Job Ref: 17013

## **RMA20180414 | RESPONSE TO FURTHER INFORMATION**

Dear Cameron  
**174-176 Brookvale Road, Hastings**  
**Section 92 Traffic Response**

TITLE: TOPOGRAPHICAL PLAN

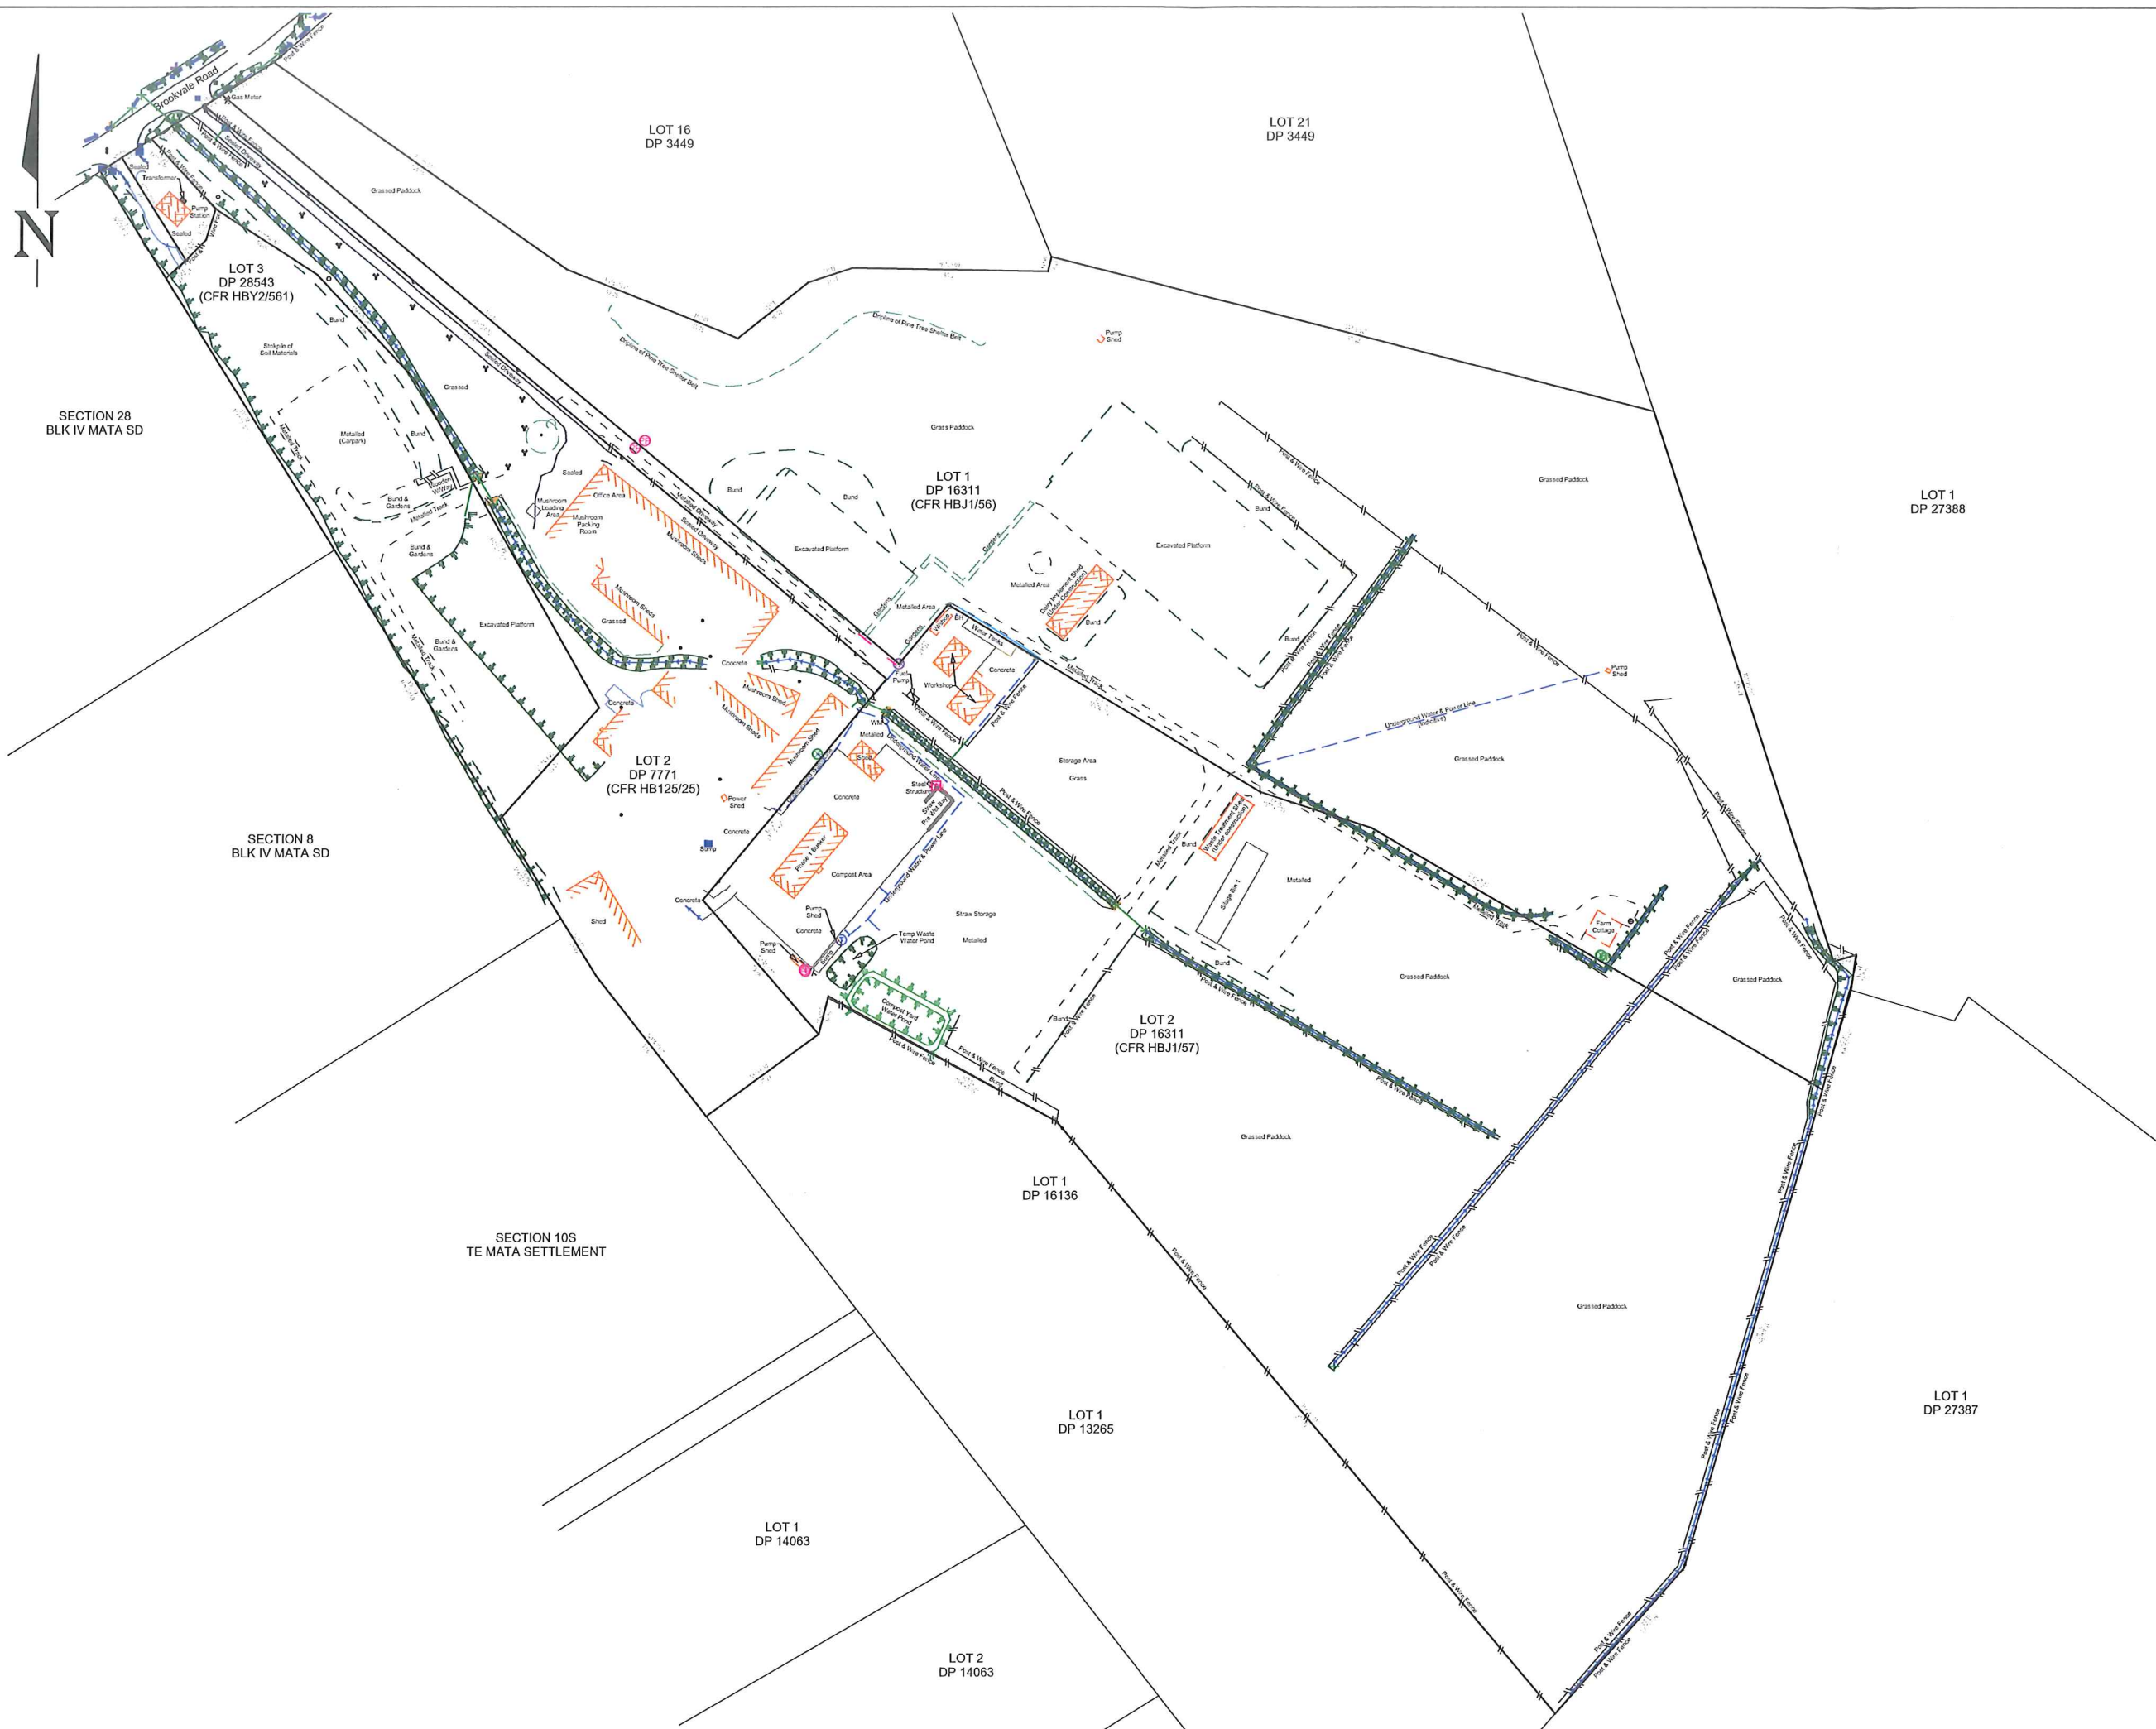
***Please provide confirmation that the pond, shed and associated infrastructure are located entirely within the subject site and do not encroach into the adjoining property.***

The Plan provided in **Attachment 1** confirms that the full extent of the pond is within Lot 2 DP 16311. Further detail in relation to the pump shed will be provided in responding to the item under 'Existing/Consented/Proposed Buildings' below.
